Re: In the Matter of the Hearing called by the Oil Conservation Commission for the purpose of considering: Application of Petro-Thermo Corporation for an Exception to Order No. R-3221, as amended, Lea County, New Mexico; Case No. 8781

Re: OCC Case 8781 - DeNovo  
Petro-Thermo Corporation Application  
for exception to Order R-3221 and for  
Authority to Disposal of Produced  
Waste in Unlined Surface Pits,  
Lea County, New Mexico

CASE NO. 8781  
ORDER NO. R-8161-A  
DeNovo

PROBLEMS WHICH HAVE NOT BEEN ADEQUATELY ADDRESSED BY PETRO-THERMO REPORT

Proposed  
 Monitoring Well  
 Sites

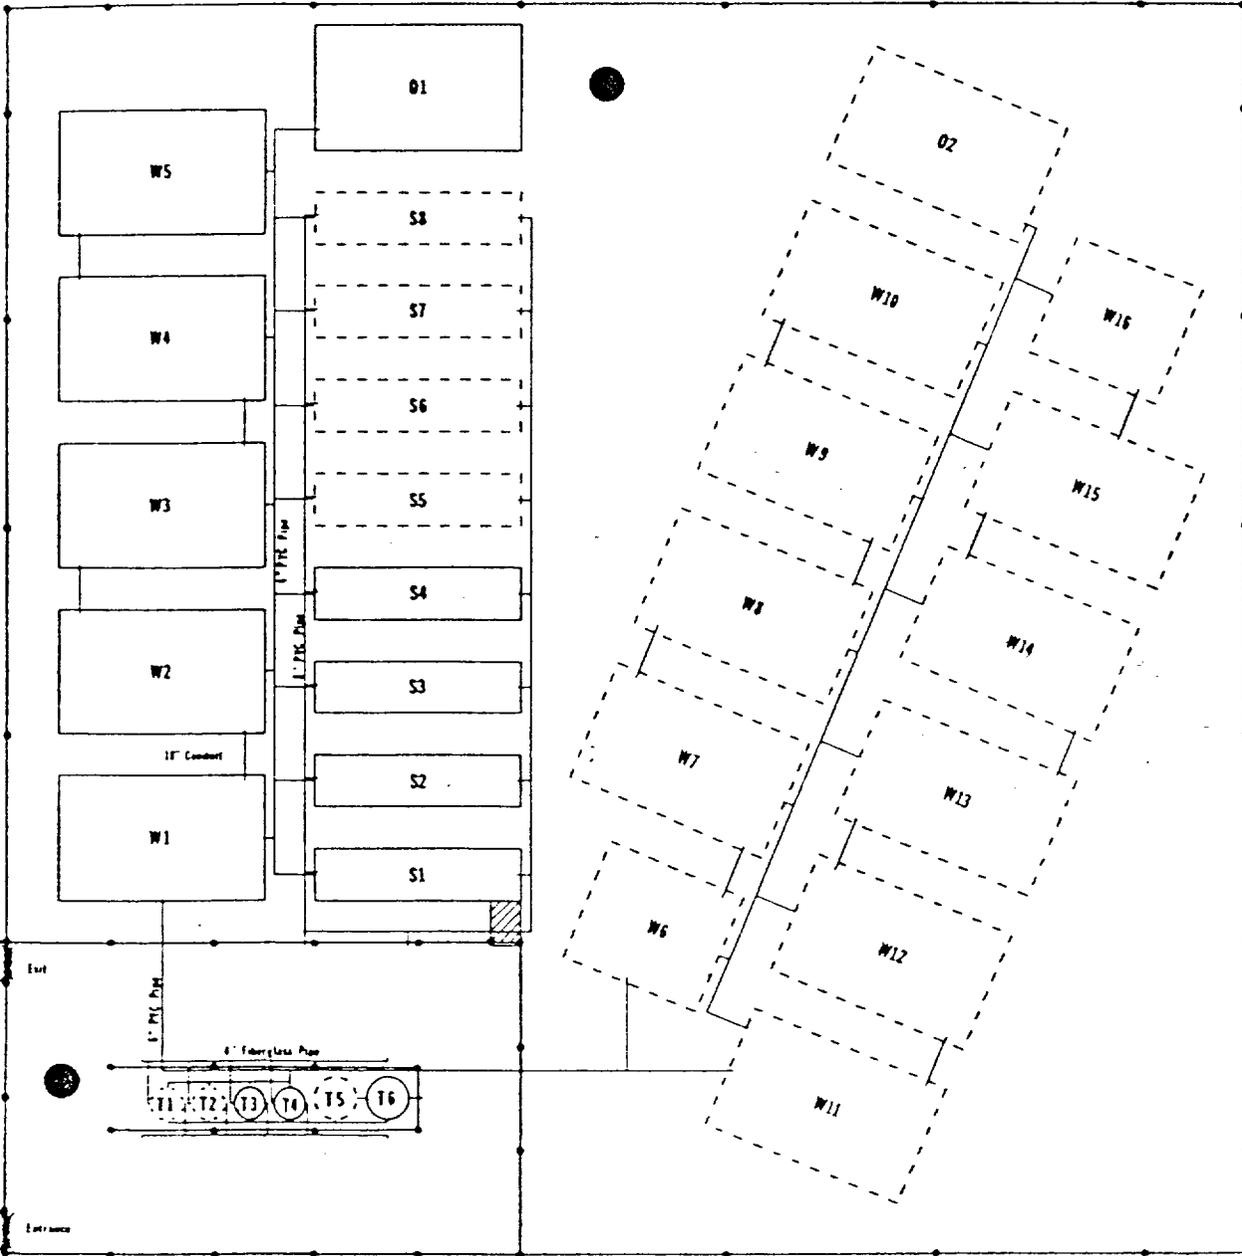
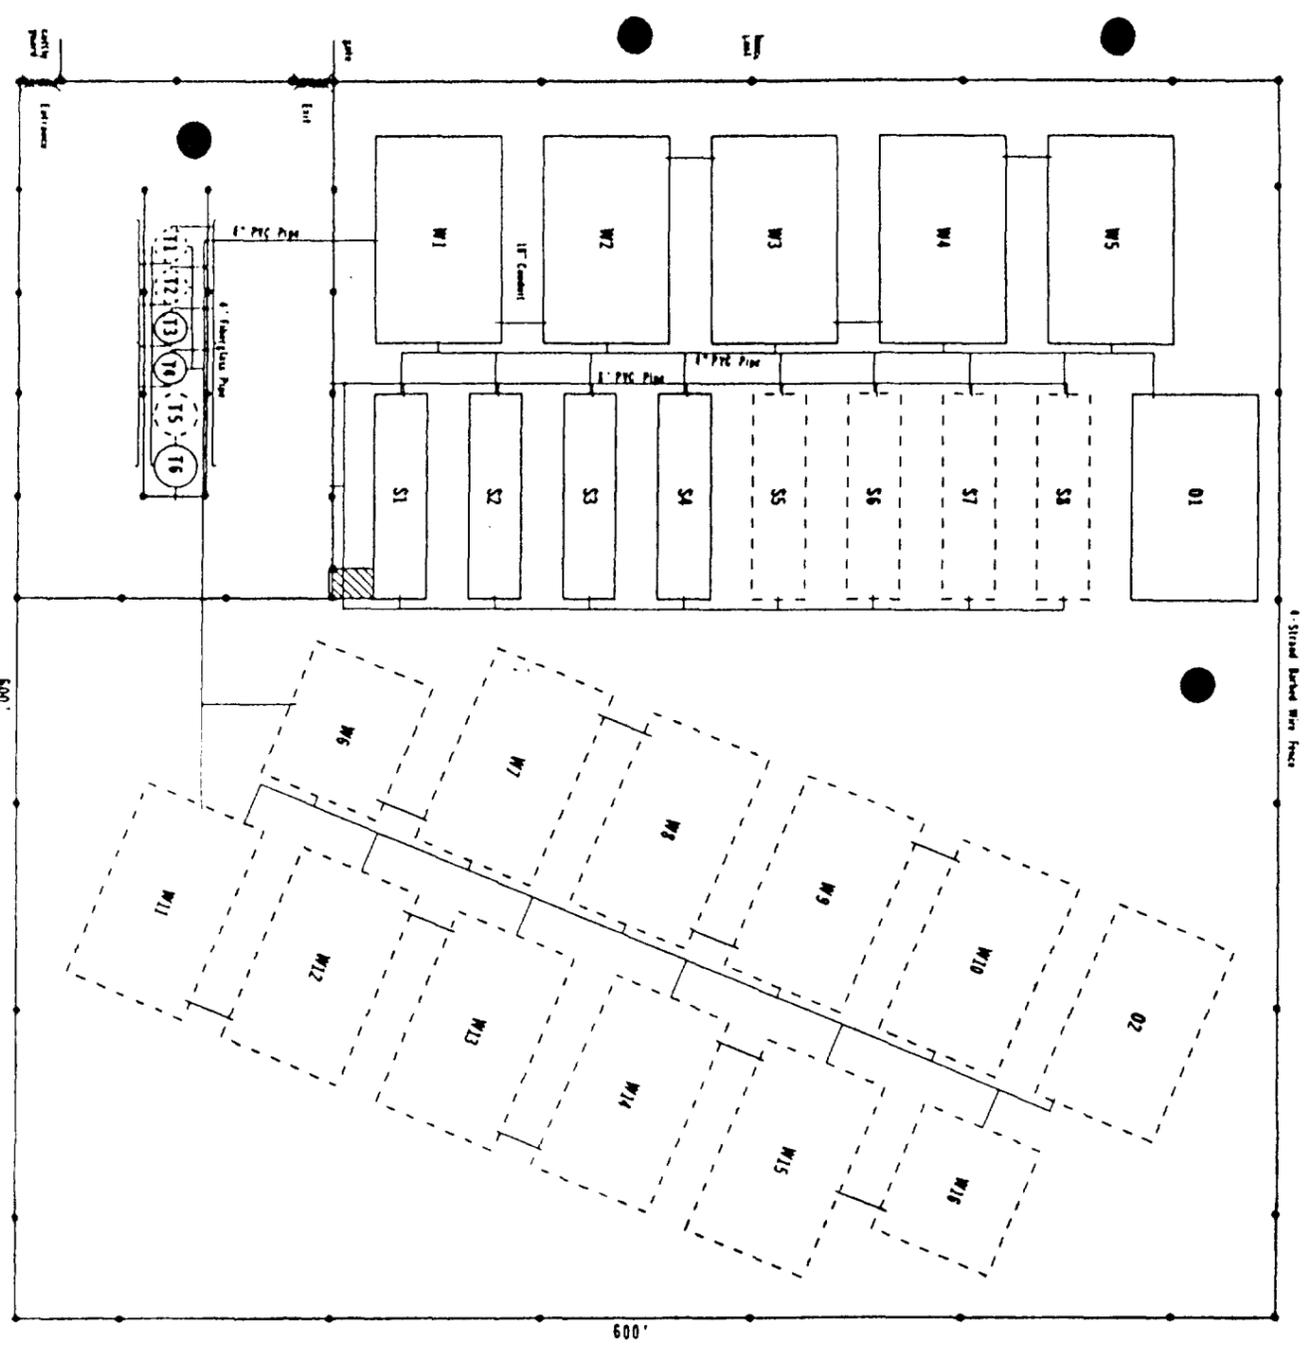
The Division's proposed monitoring wells, as set forth in its letter dated February 18, 1986, is not adequately designed to detect migration of the produced water. Even if they do happen to detect the produced water as it migrates, all the monitoring wells will do is confirm that the produced water has migrated off of the facility. The monitoring wells do not provide any element of protection to the adjoining owners.

(32) The proposed monitor wells are not adequate to detect migration of discharge water offsite and cannot be effectively utilized for cleanup of any environmental damages that the facility may cause.

Proposed Monitoring Well  
 (Schematic)

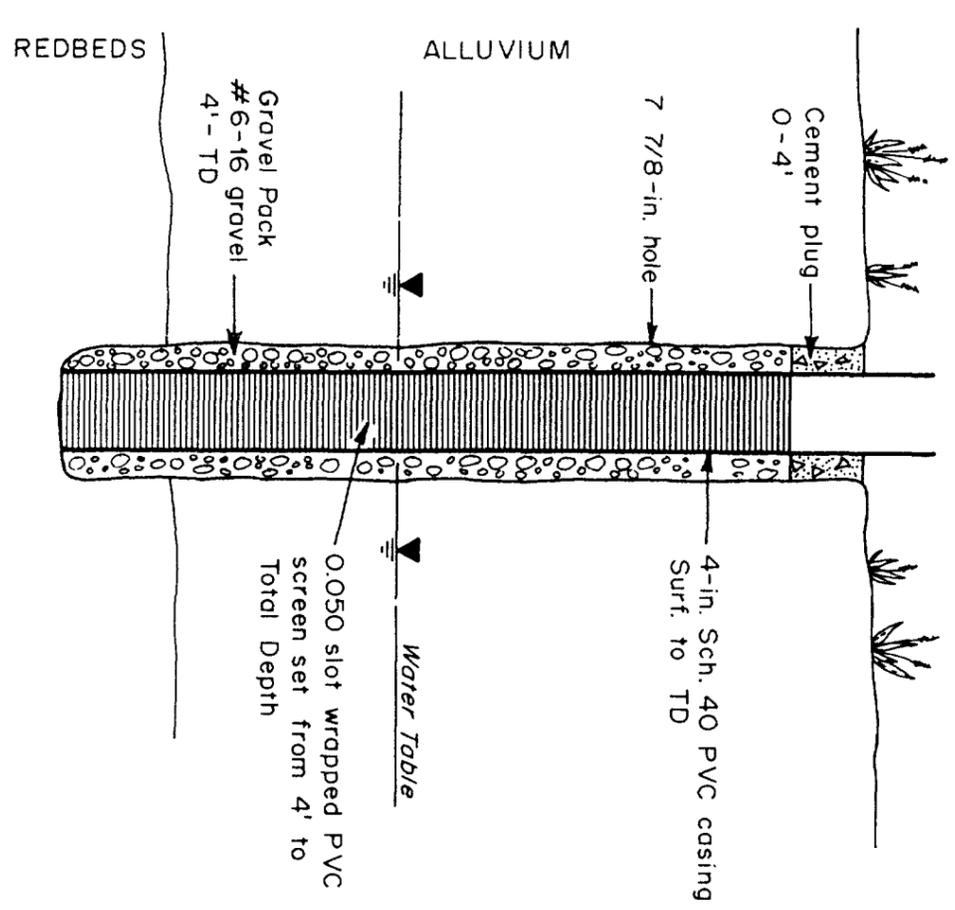
*Well should be drilled with air from surface to five feet below top of redbeds. Run geophysical logs for SP, resistivity, gamma and neutron.*
